City of Santa Fe, New Mexico

memo

2024-009612-HDRB, 1126 Camino Delora, Downtown & Eastside Historic District, vacant lot, Marc Naktin, agent for Gary Shockley, owner, proposes to construct a 3,800 sq. ft. residence to a height of 19'-10" where the maximum allowable is 16'-2". The additional 3'-8" in height is requested per section 14-5.2(D)(9)(c)(ii)(f) the Board may increase the allowable height for proposed buildings and additions located on a sloping site where the difference in the natural grade along the structure's foundation exceeds two (2) feet.

Figure 2. West Elevation of proposed structure with slope.

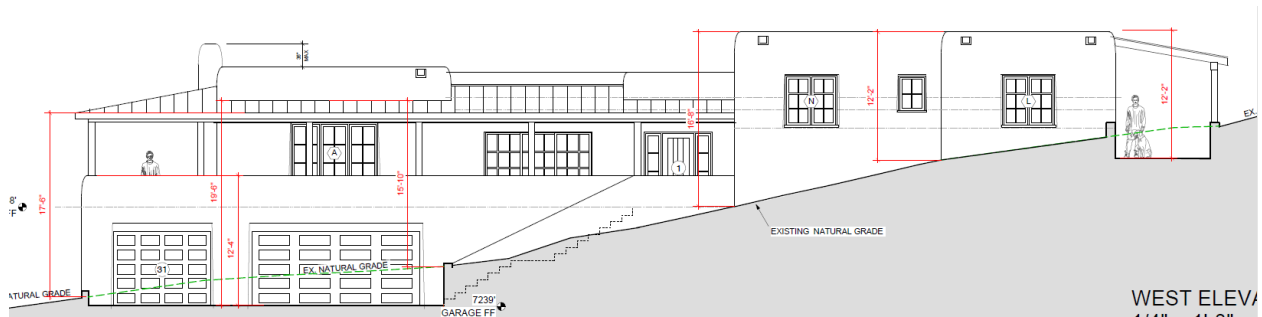
1. Construct a 3,800 sq. ft. single-family detached residence in a Spanish Pueblo Revival style to a height of 19'-10" at the highest point where the maximum allowable is 16'-2". The height of the structure at the top of the slope is 12'-2". The additional 3'-8" in height is requested per section 14-5.2(D)(9)(c)(ii)(f) where the Board may increase the allowable height by four (4) feet at their discretion without the need for an exception for proposed buildings and additions located on a sloping site where the difference in the natural grade along the structure's foundation exceeds two (2) feet.

Staff recommends approval of the proposed project and finds that the application complies with Section 14-5.2(D) General Design Standards for all Historic Districts, and 14-5.2(E) Downtown and Eastside Design Standards.
